MUNICIPAL SEPARATE STORM SEWER SYSTEM (MS4) TMDL PLAN TECHNICAL REVIEW CHECKLIST¹

Applicant Name: East Bradford Township NPDES Permit No.: PAI130523

TMDL Plan Technical Review Checklist

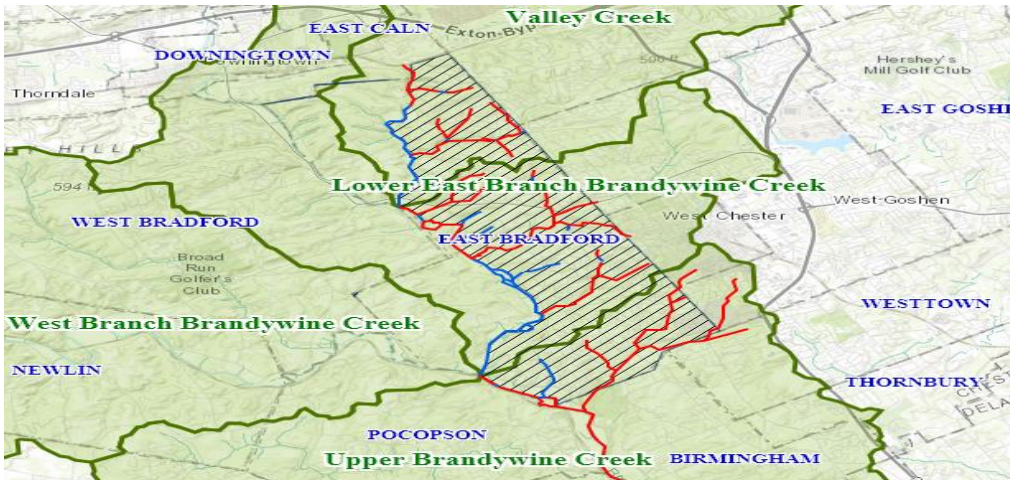
Comments: The DEP's GIS shows East Bradford Township's UA in the map:
